LICENSEE: Union Electric Company

FACILITY: Callaway Plant

SUBJECT: SUMMARY OF MEETING WITH UNION ELECTRIC COMPANY ON NOVEMBER 12, 2003, TO DISCUSS TWO LICENSEE APPLICATIONS AND POTENTIAL INSTRUMENTATION DIGITAL UPGRADES AT THE PLANT (TAC NOS. MB9875, MB9876, AND MB9879)

MEETING OF NOVEMBER 12, 2003, WITH CALLAWAY PLANT

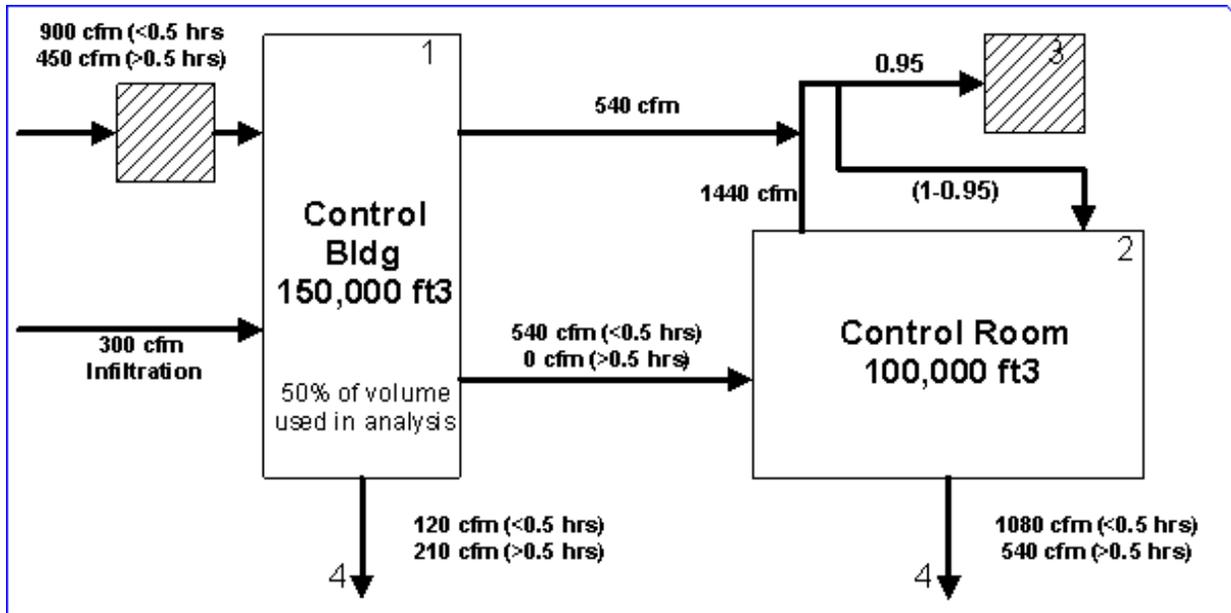
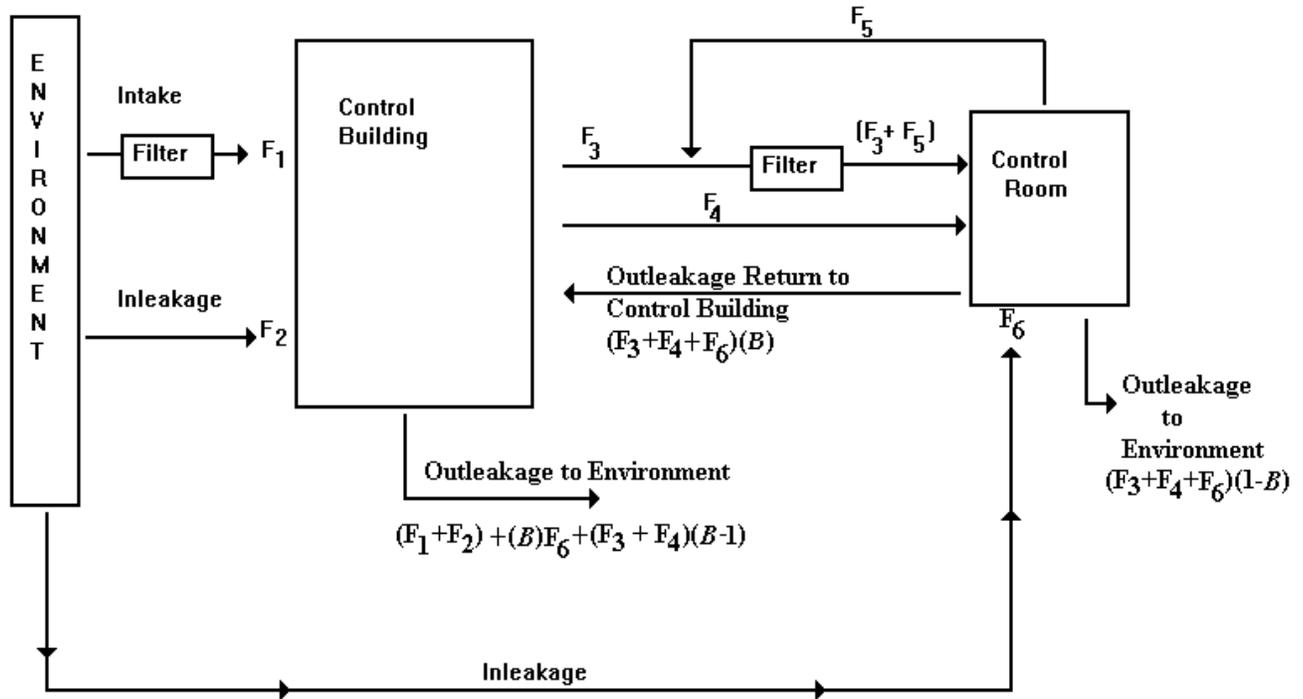
The figure below represents the staff's interpretation of appropriate modeling of your control building and control room. Node 3 is the recirculation filter; node 4 is a "sink." Discuss the staff's interpretation and confirm if the staff's understanding is correct. In particular, discuss if the expected re-alignment will occur at 30 minutes for this event and provide the basis for this conclusion.

The staff's flow diagram does not match the one used by AmerenUE. The following diagram is taken from Section 15A of the Callaway FSAR:

The diagram has two flow paths not shown on the staff's diagram. The first is direct leakage from the environment to the Control Room. The second represents Control Room leakage returning to the Control Building.
